**TRANSMITTAL OF THE POSTCONSTRUCTION REPORT FOR THE NORTHEAST
PLUME OPTIMIZATION AT THE PADUCAH GASEOUS DIFFUSION PLANT,
PADUCAH, KENTUCKY, DOE/LX/07-2419&D2**

**Postconstruction Report for the
Northeast Plume Optimization at the
Paducah Gaseous Diffusion Plant,
Paducah, Kentucky**

**Response to U.S. Environmental Protection Agency
Comments Submitted March 21, 2018
*Postconstruction Report for the
Northeast Plume Optimization at the
Paducah Gaseous Diffusion Plant,
Paducah, Kentucky, Document No. DOE/LX/07-2419&D1***

**Response to Kentucky Department for Environmental Protection
Comments Submitted April 2, 2018,
*Postconstruction Report for the Northeast Plume Optimization
at the Paducah Gaseous Diffusion Plant,
Paducah, Kentucky, DOE/LX/07-2419&D1***

Figure 1. Location of Wells & Piezometers Installed for the Northeast Plume Interim Remedial Action Optimization Project

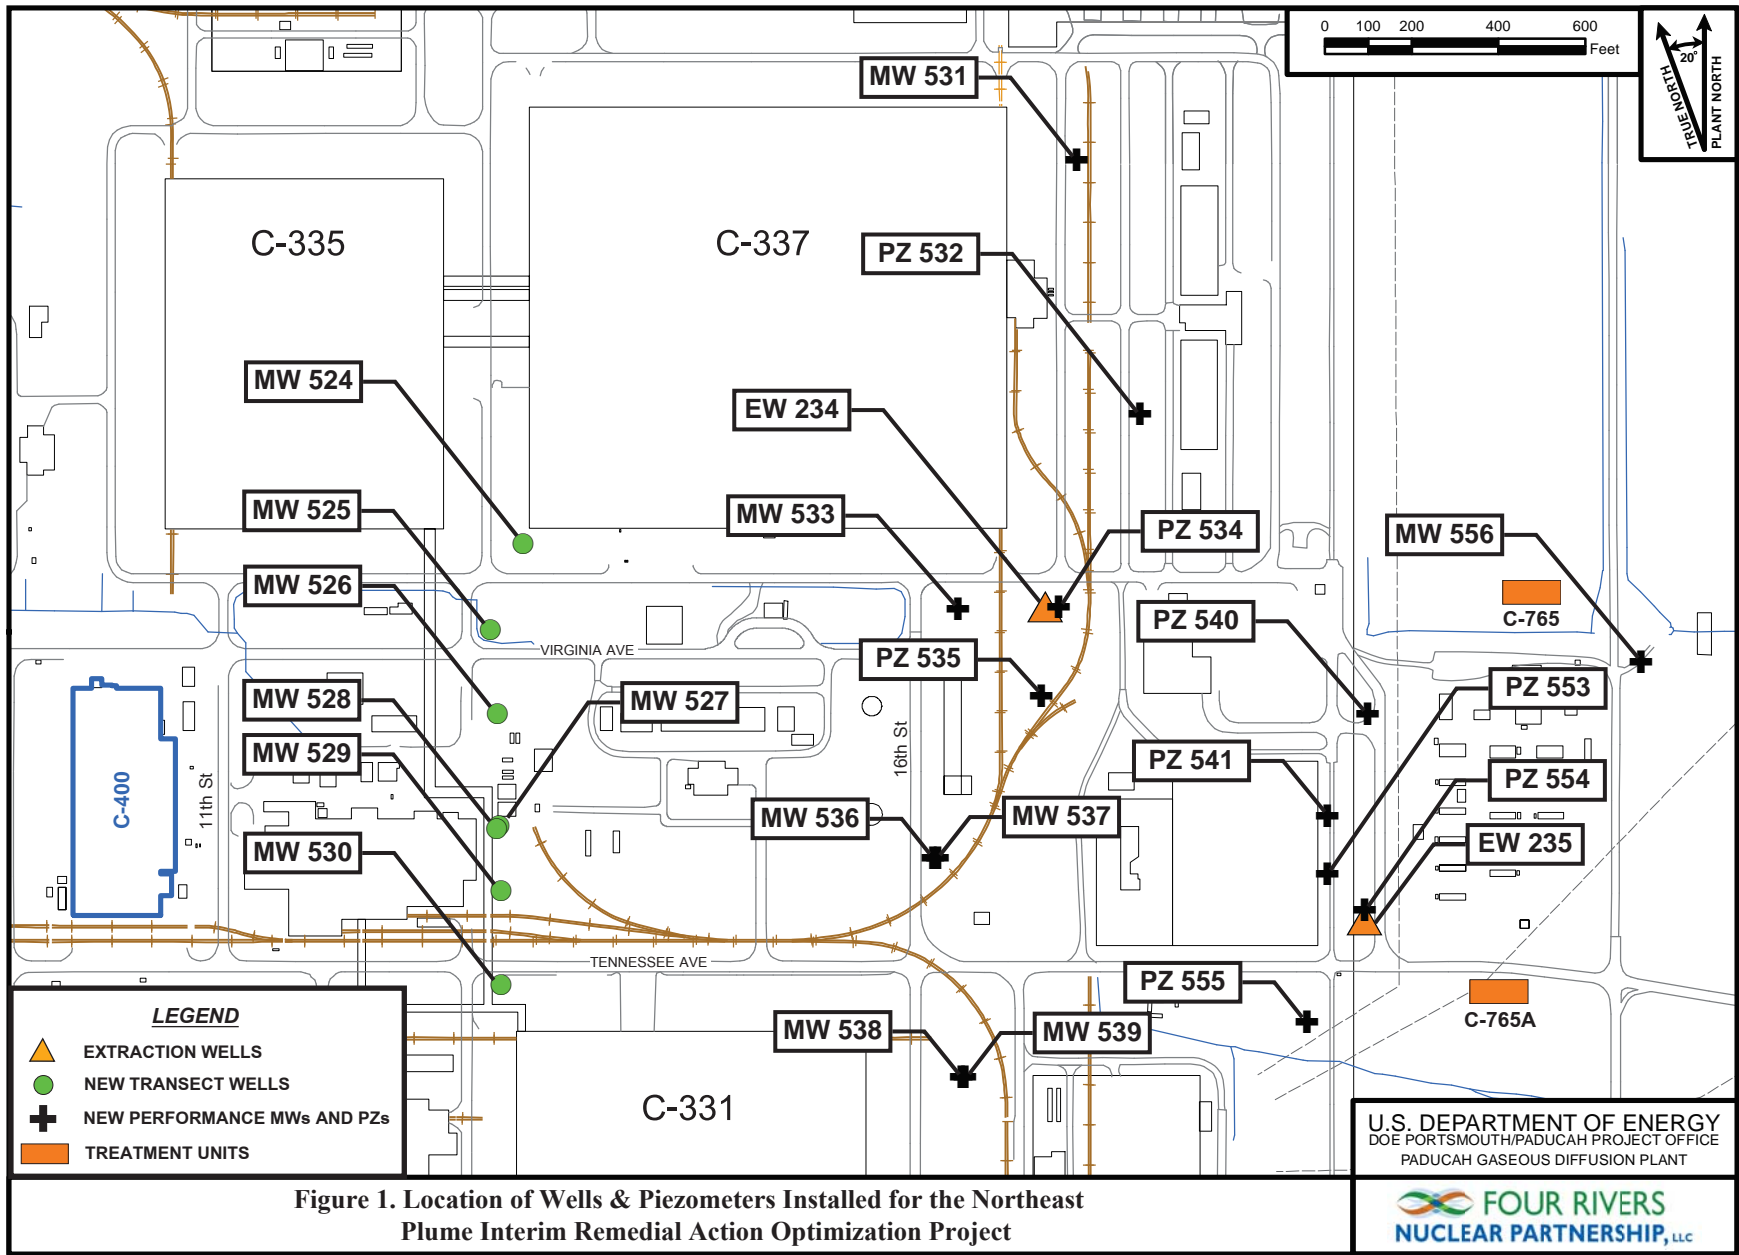
Comment 3: Figure 1 (Location of Wells & Piezometers Installed for the Northeast Plume Interim Remedial Action Optimization Project) includes the locations of the extraction wells, new transect wells, new performance monitoring wells and piezometers and treatment units. However, the extent of the Northeast Plume is not shown on the figure to provide context relative to the location of the wells and piezometers installed for the Northeast Plume Interim Remedial Action Optimization Project.

- While the extent of the Northeast Plume is provided in documents referenced in the PCR, for completeness, Figure 1 should be revised to include the extent of the Northeast Plume at the time of the Northeast Plume Interim Remedial Action Optimization Project. Plume extent is defined as the constituent-specific detection limit.

Response 3: Requested comment incorporated. Figure 2, Northeast Plume Extraction Well Field with 2016 TCE Plume Map, has been added to the report that maps the extent of TCE at 5 µg/L and identifies sample locations with TCE levels of 1–5 µg/L, less than 1 µg/L (the common laboratory reporting limit), and Not Detected.
